Ducuesne Light Company Beaver Valley Power Station

Reference: Beaver Valley Power Station, Unit No. 1 Docket No. 50-334, License No. DPR-66 Response to R. G. 1.97

## Steam Generator Wide Range Level Instrumentation

## Problem Description and NRC Request

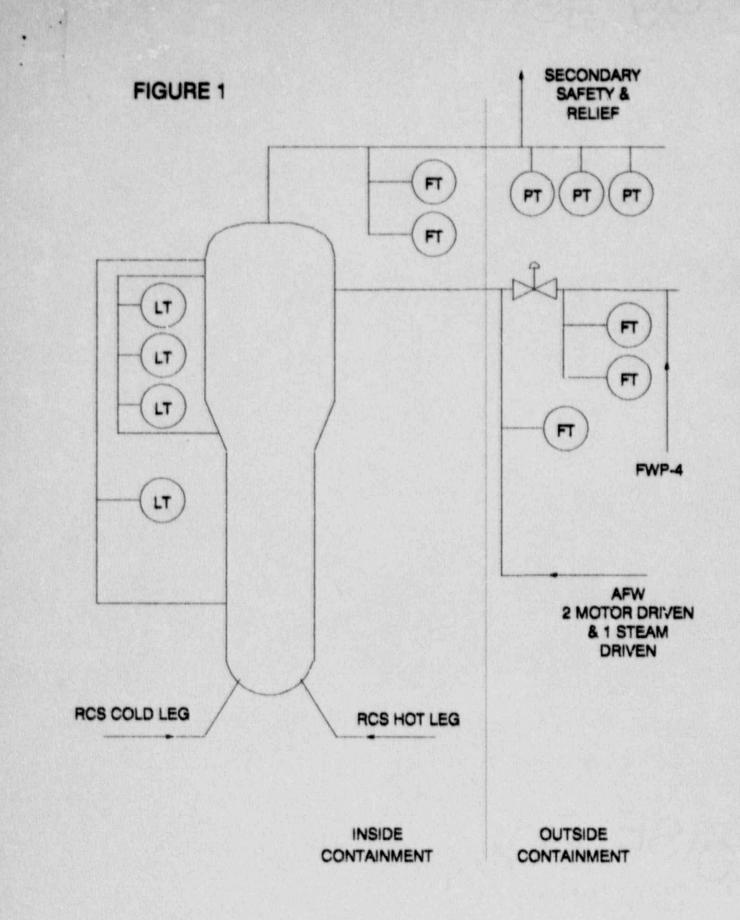
The three procedures utilizing the SGWR instrumentation are FR-H.1, "Response To Loss of Secondary Heat Sink", FR-H.5 "Response to SG Low Level", and ECA-00, "Loss of All Emergency 4KV AC Power." FR-H.1 and FR-15 were discussed above in Section 2. They are primarily entered when required from the "Heat Sink" Status Tree F-0.3. The entry conditions are shown on Figure 2 for FR-H.1, FR-H.5 and ECA-0.0.
